A NEW MEDICAL MARIJUANA DISPENSARY INTERIOR TENANT FINISH FOR:

ORIGINAL ISSUE DATE: DECEMBER 7, 2022
ADDENDUM 1 ISSUE DATE: JANUARY 19, 2023

ADDENDUM 1 SUMMARY

16
A100
RENOVATION FLOOR PLAN
SCALE: 1/4" = 1'-0"

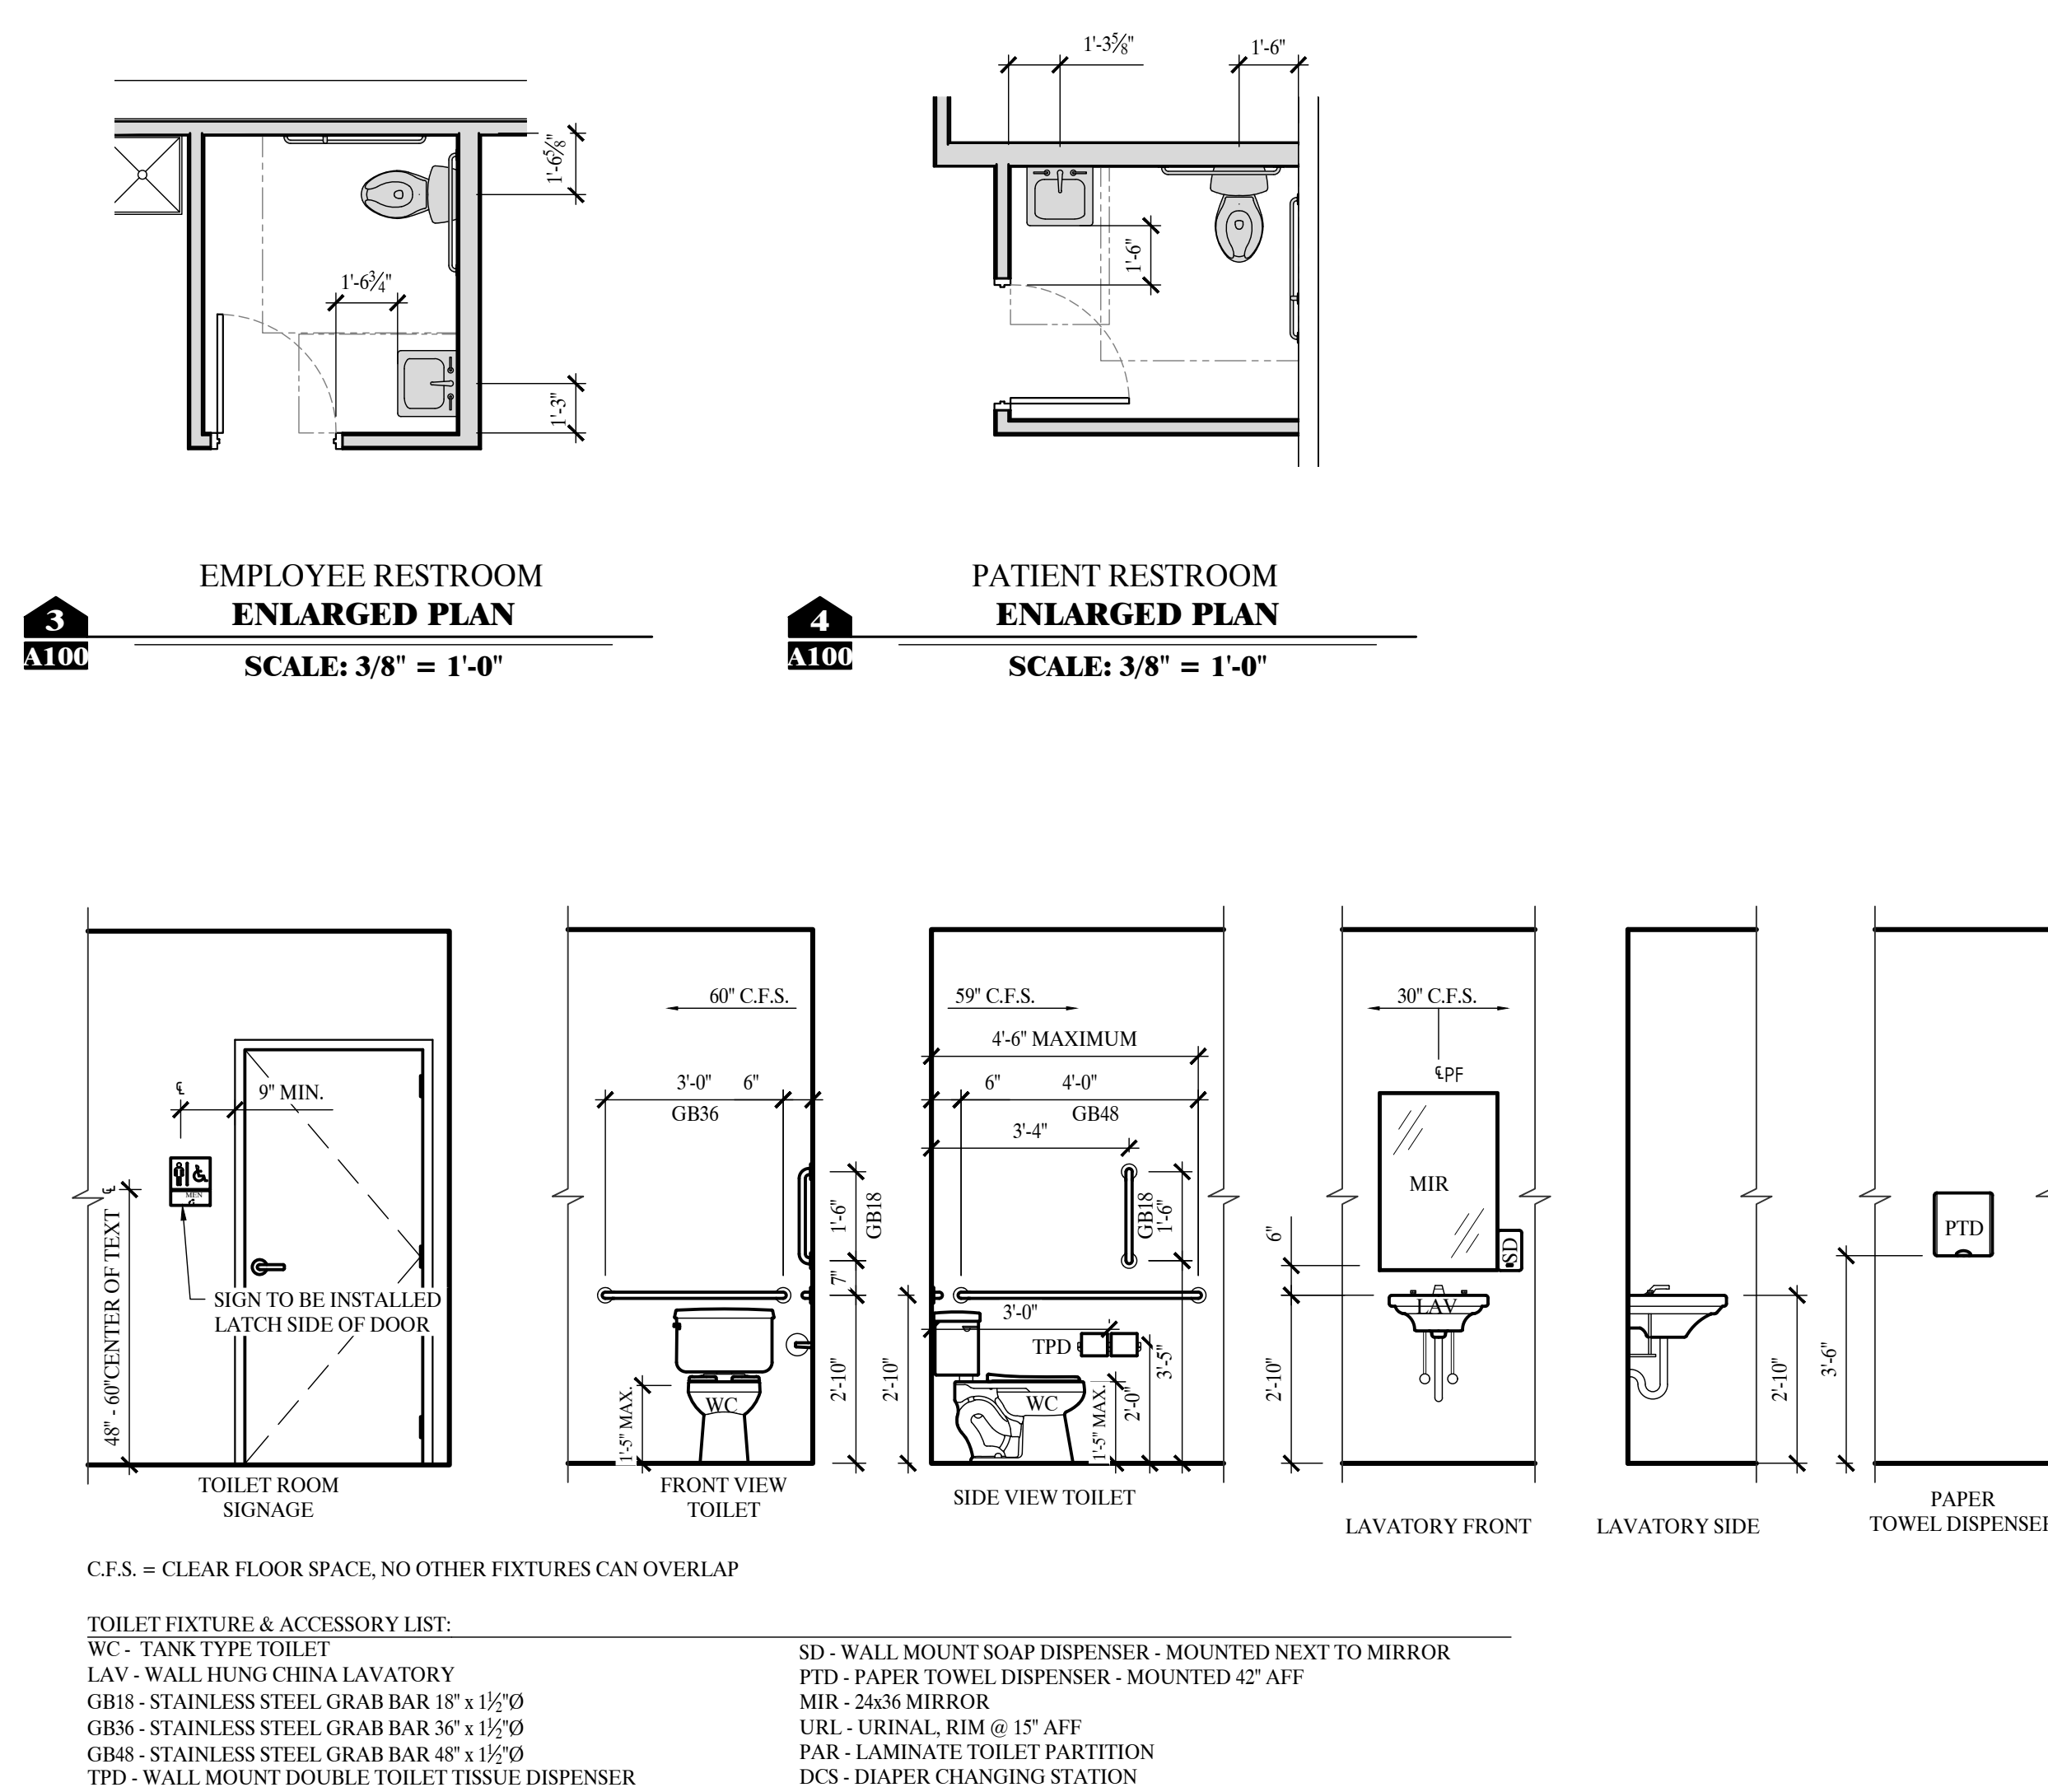
- RESPONSE TO PLAN REVIEW COMMENTS (5/23/2022)**
- PATIENT TOILET 104 IS MODIFIED TO PROVIDE THE MINIMUM 18" CLEARANCE AT LATCH SIDE OF DOOR.
 - A BOTTLED WATER APPLIANCE SHALL BE PROVIDED.

CLG. FRAMING,
REFL. CEILING
PLAN

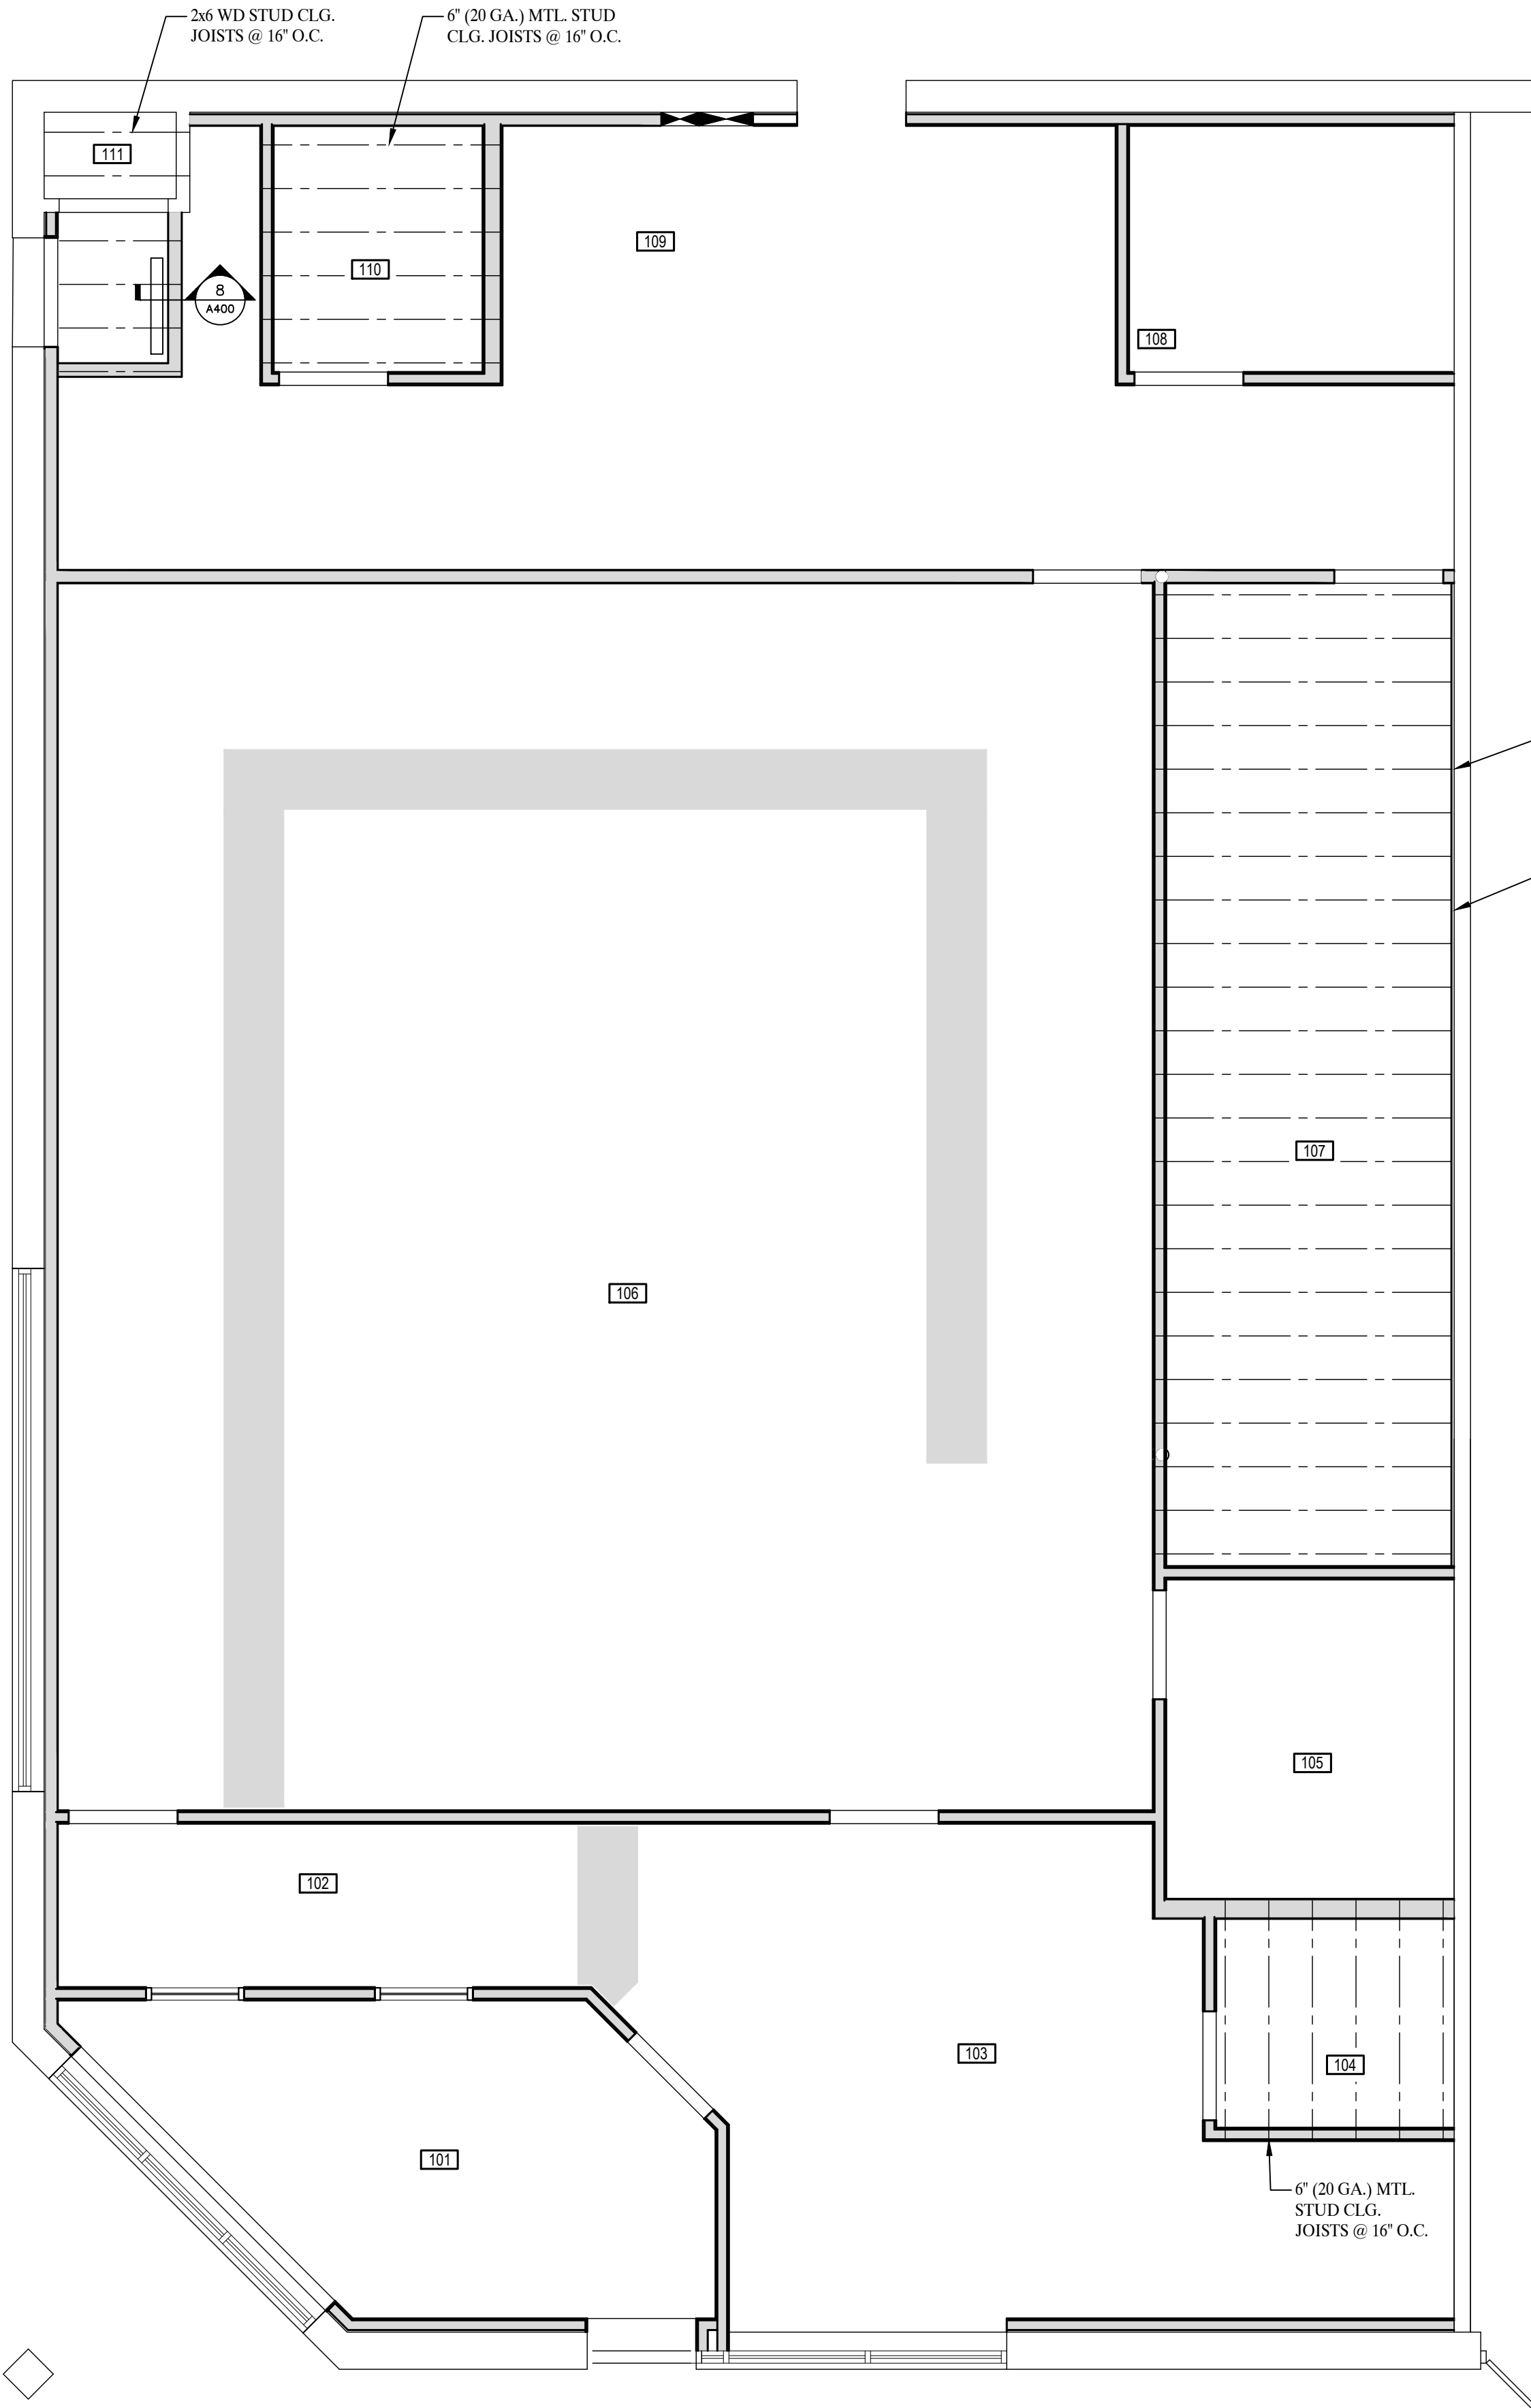
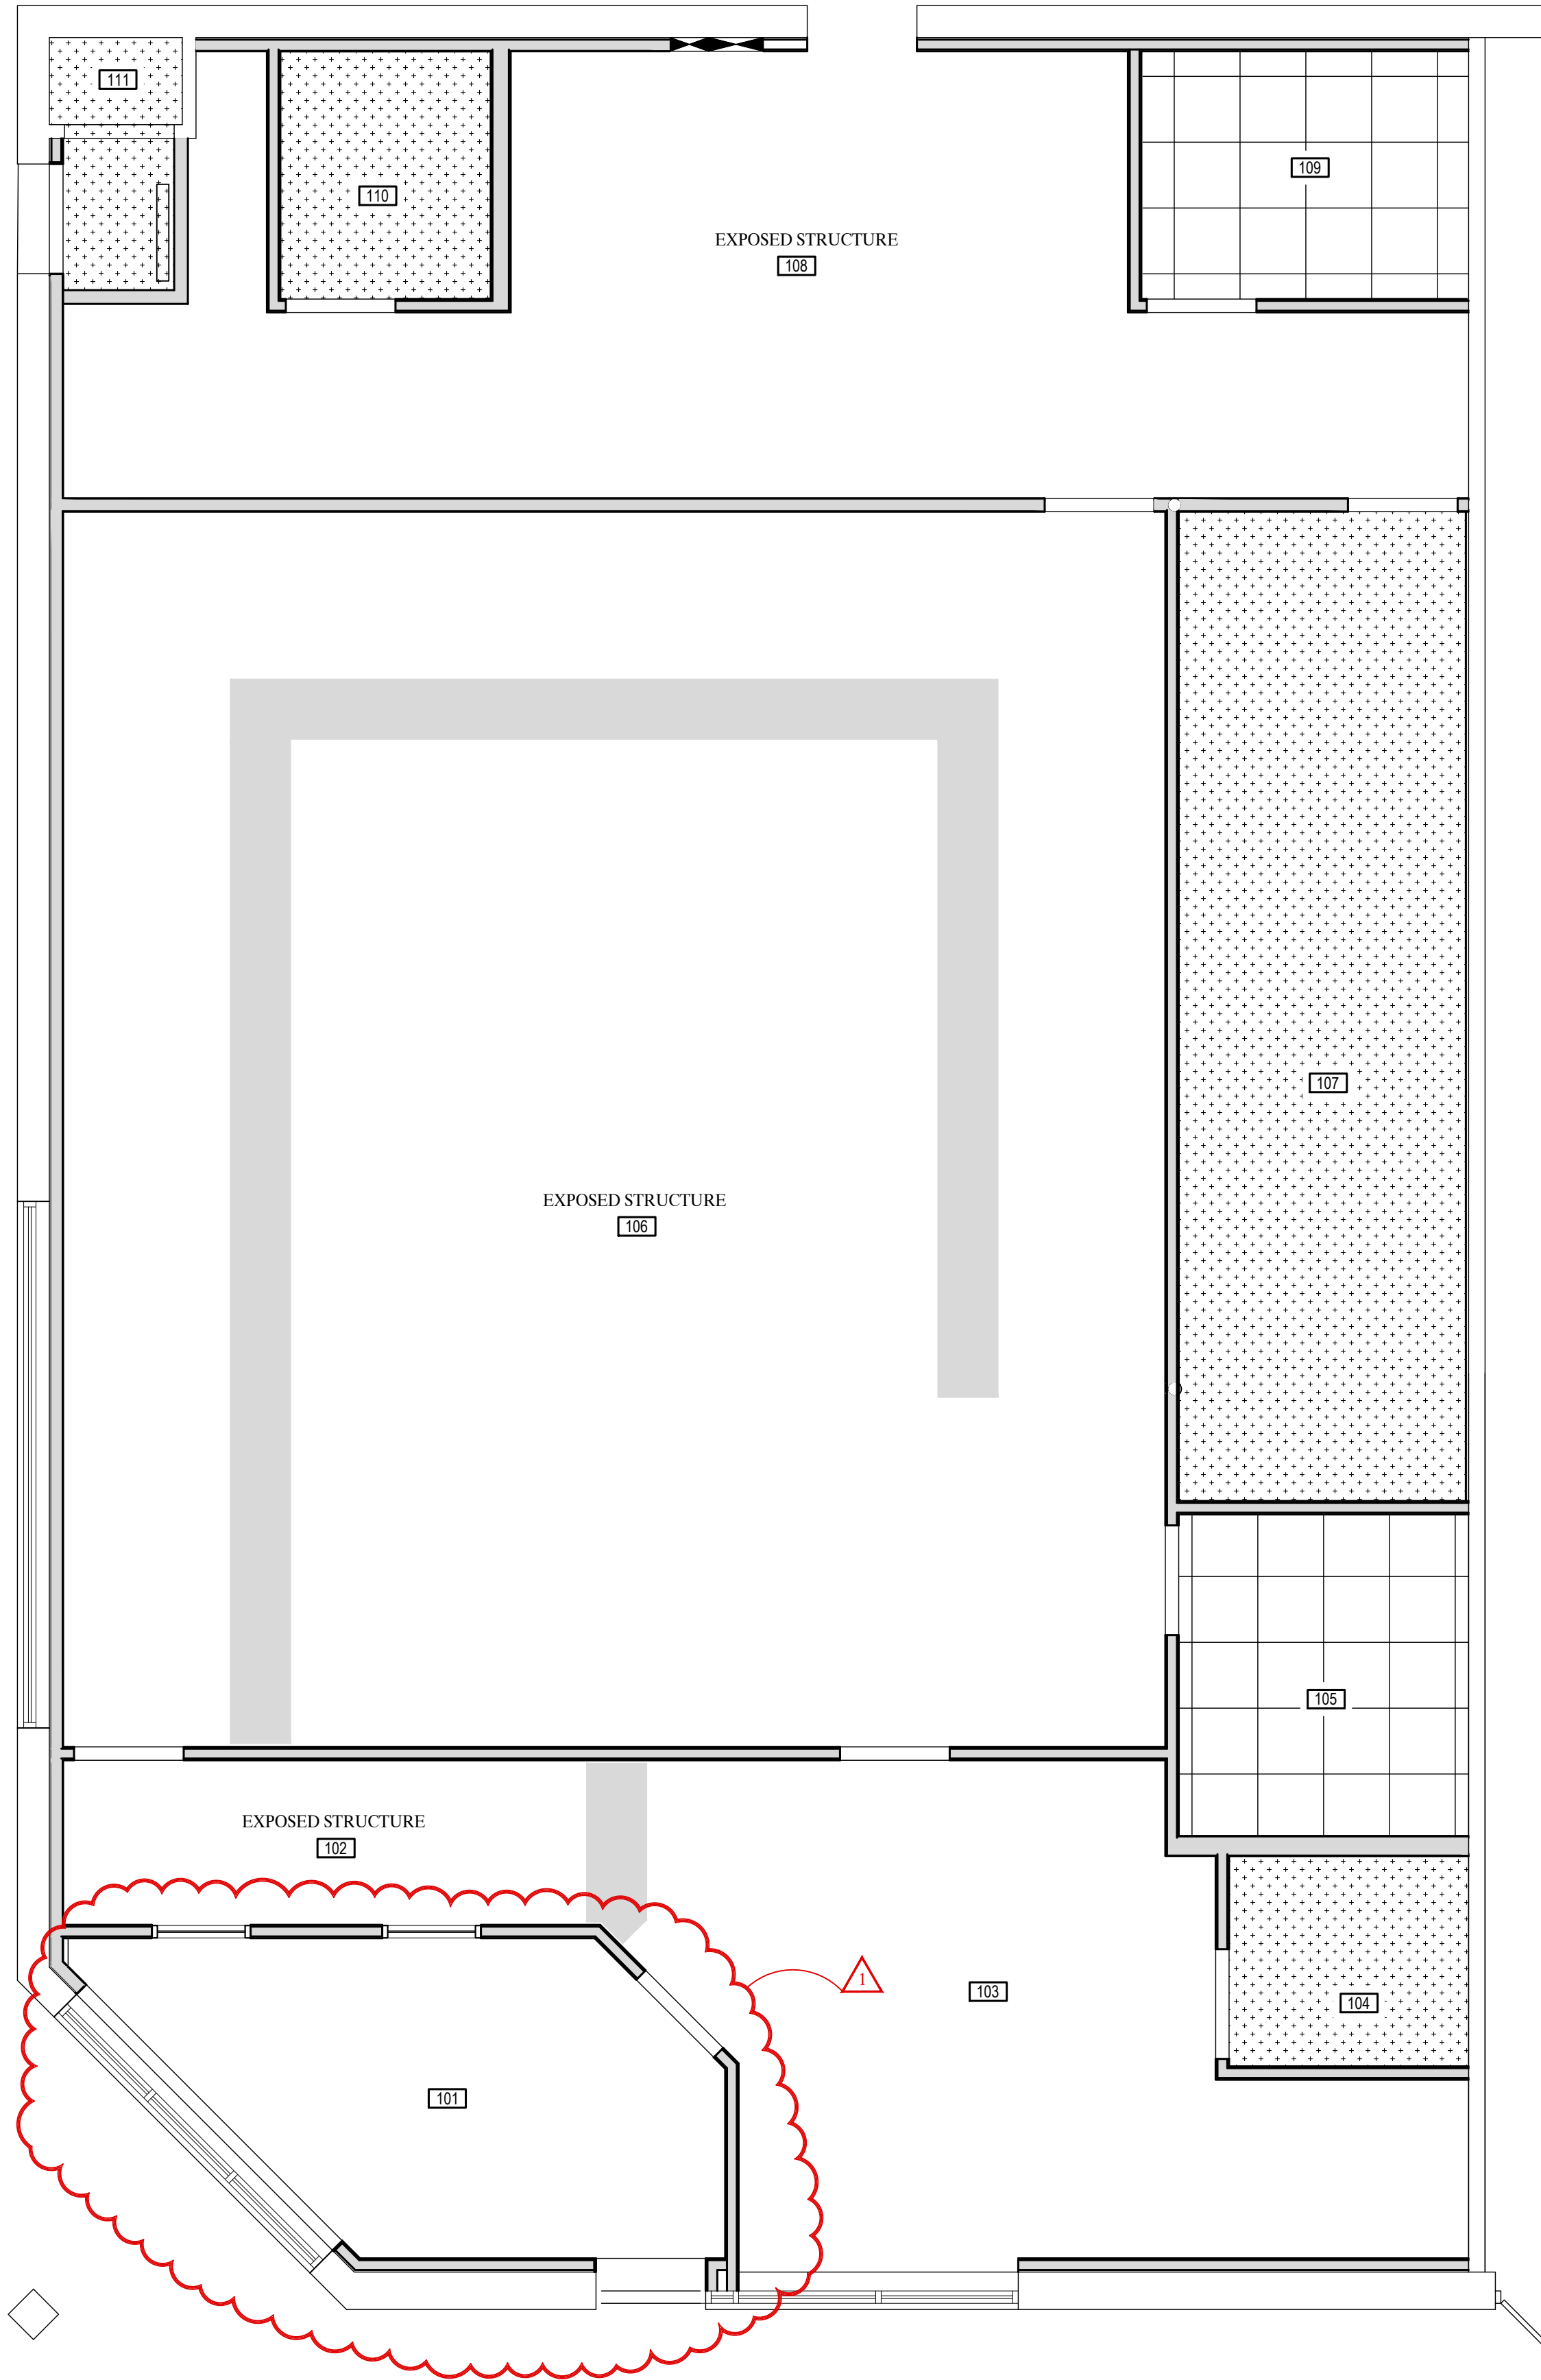
REFLECTED CEILING PLAN REVISED REMOVING CEILING IN ROOM 101
